Re: Brown County Landfill Cell #5 Construction
Helms A-9908

ADDENDUM NUMBER 1

The following modifications are made to the plans and specifications for the Brown County Landfill Cell #5 Construction.

HYDROGEOLOGICAL ASSESSMENT
 CROSS-SECTION C-C'

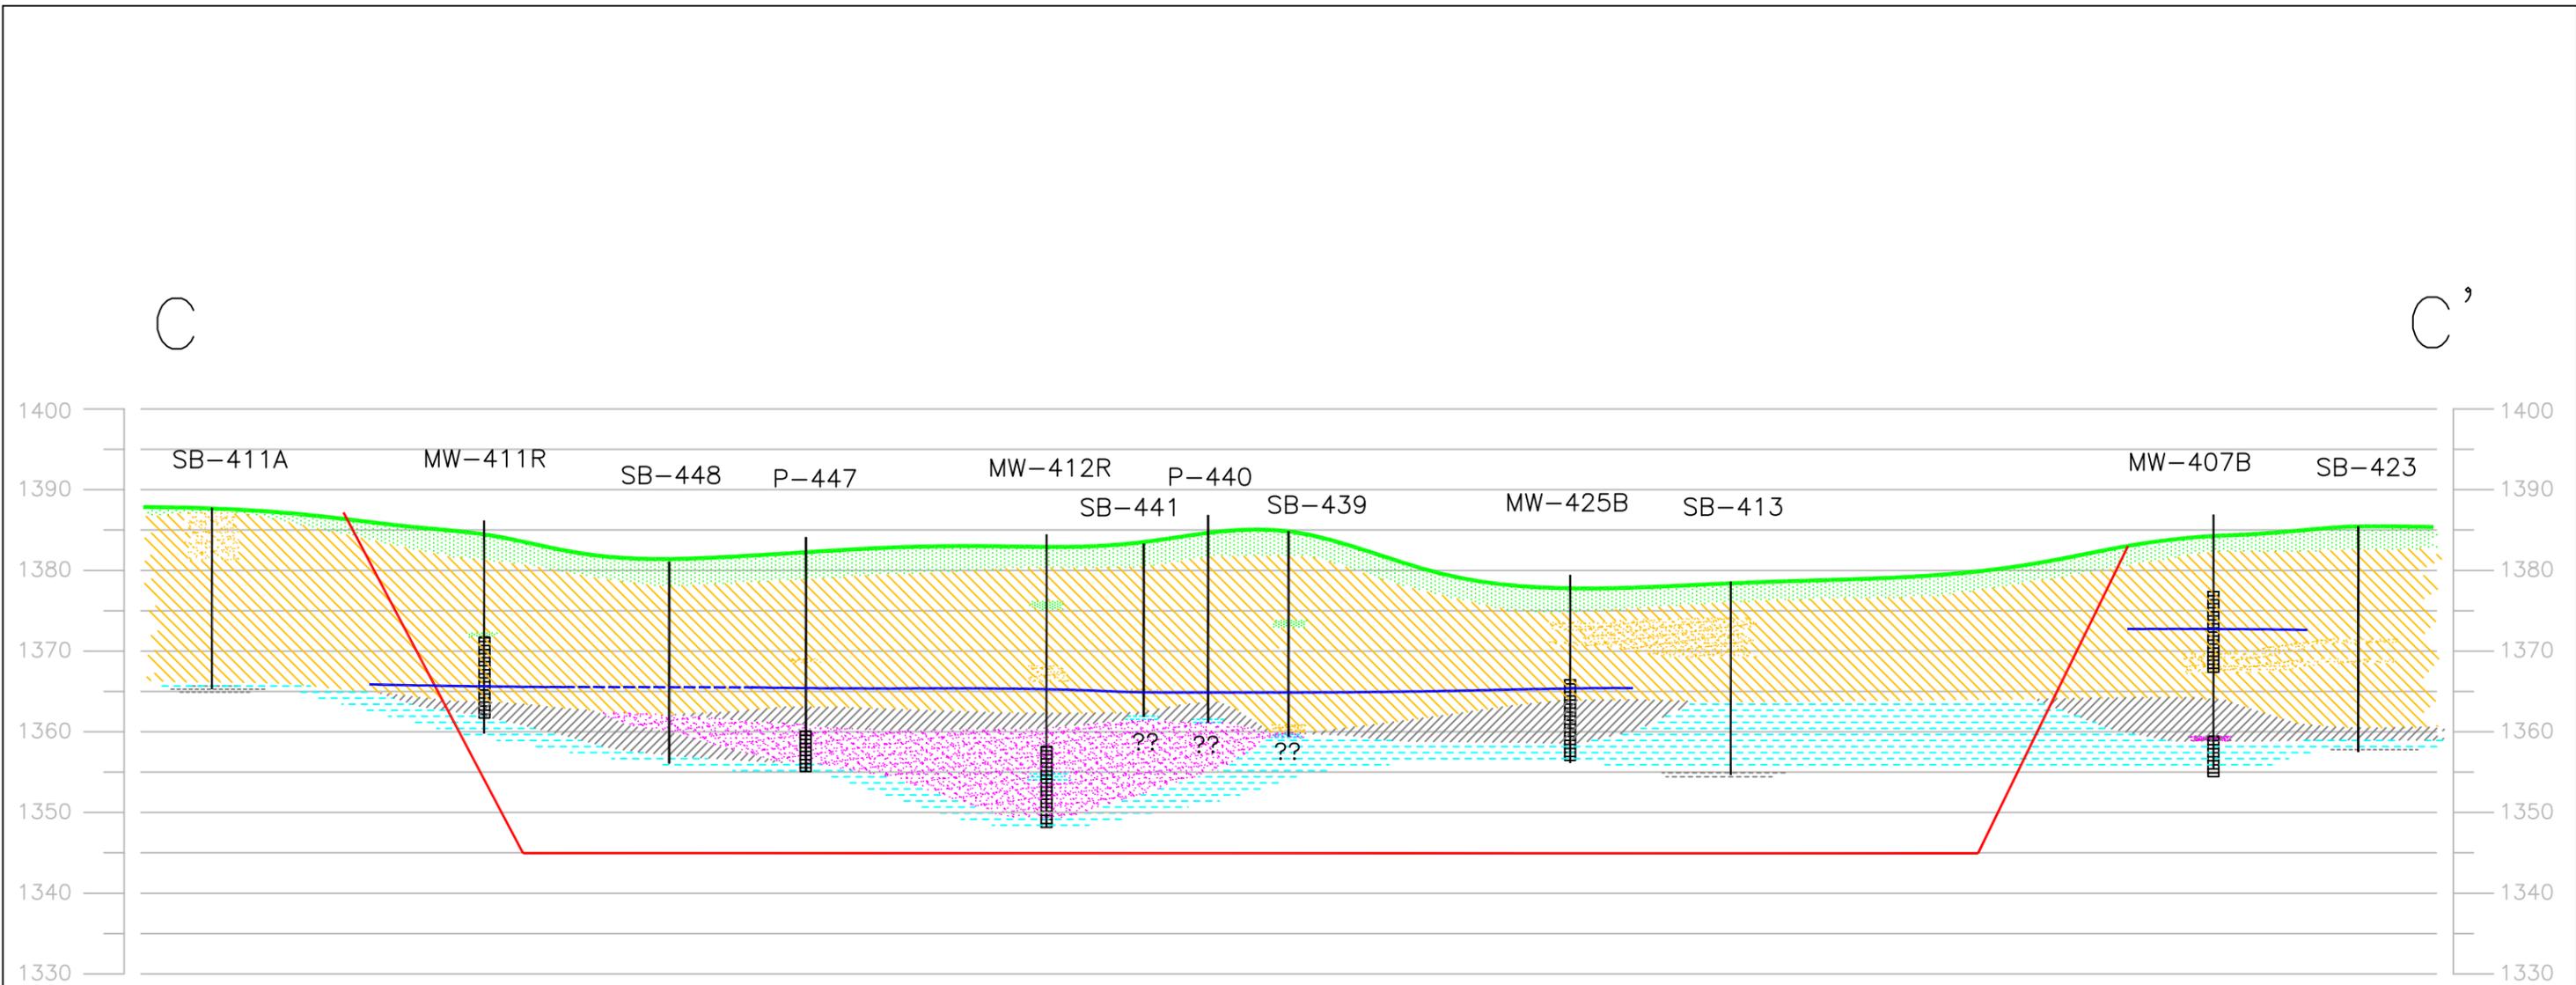
Relevant Additional Figures and cross sections are attached to this addendum. Cross Section "C" includes monitoring well to be abandoned. For informational purposes only.
